Access Compliance Report

Public Rights-of-Way

Intersection ID: 45738	Main Street: PACIFIC_ECHO_DR	Cross Street: PRESCOTT_HILL_AV	Location: SE
ADA ID: 83E53839D5E4	Ramp Type: PerpDiag	Initial Pass/Fail: Fail	Overall Compliance: No
Severity Score: 22.5			
Codes/Mitigation Info/Possible Solution		Field Measurements/Component Compliance

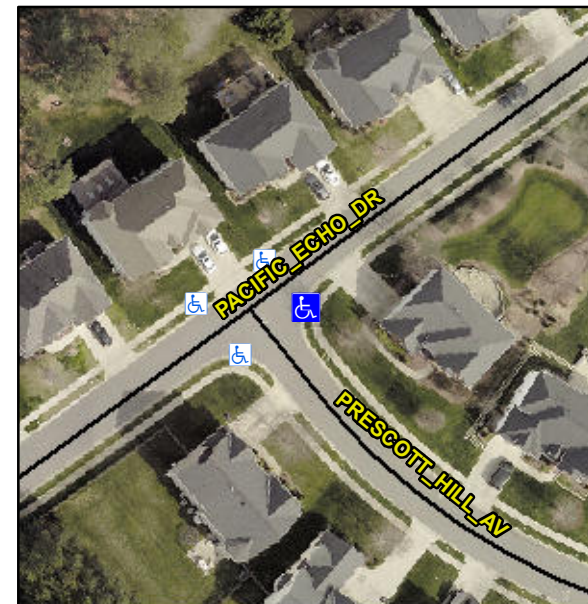
Not Found, R304.5.1, R304.2.2, R304.5.3

Compliance	Description	Data	Compliance	Description	Data
N/A	Ramp Length (in)	49.0	No	Ramp Slope (%)	8.8
No	Ramp Width (in)	41.0	No	Ramp XSlope (%)	4.3
N/A	Flare Type LT	N/A	N/A	Flare Type RT	N/A
N/A	Flare Slope LT (%)	N/A	N/A	Flare Slope RT (%)	N/A
N/A	Flare Traversable LT?	N/A	N/A	Flare Traversable RT?	N/A
N/A	Landing Length (in)	N/A	N/A	DWS Provided?	N/A
N/A	Landing Width (in)	N/A	N/A	DWS Contrast?	N/A
N/A	Landing Slope (%)	N/A	N/A	DWS Length (in)	N/A
N/A	Landing X Slope (%)	N/A	N/A	DWS Full Width?	N/A
N/A	Landing Curb? (Y/N)	N/A	N/A	DWS Offset (in)	N/A
N/A	Shared Landing?	N/A			
N/A	Gutter Ponding?	N/A	N/A	Gutter Slope (%)	N/A
N/A	Gutter Lip Ht (in)	N/A	N/A	Gutter X Slope (%)	N/A
N/A	Painted X Walk1?	No	N/A	Painted X Walk2?	No
	X Walk 1 Direction	To NW		X Walk 2 Direction	To SW
N/A	X Walk 1 Width (in)	N/A	N/A	X Walk 2 Width (in)	N/A
	X Walk 1 Slope (%)	4.3		X Walk 2 Slope (%)	0.5
	X Walk 1 X Slope (%)	2.8		X Walk 2 X Slope (%)	4.0

Remove & Replace Curb Ramp With Two New Directional Ramps or Equivalent.
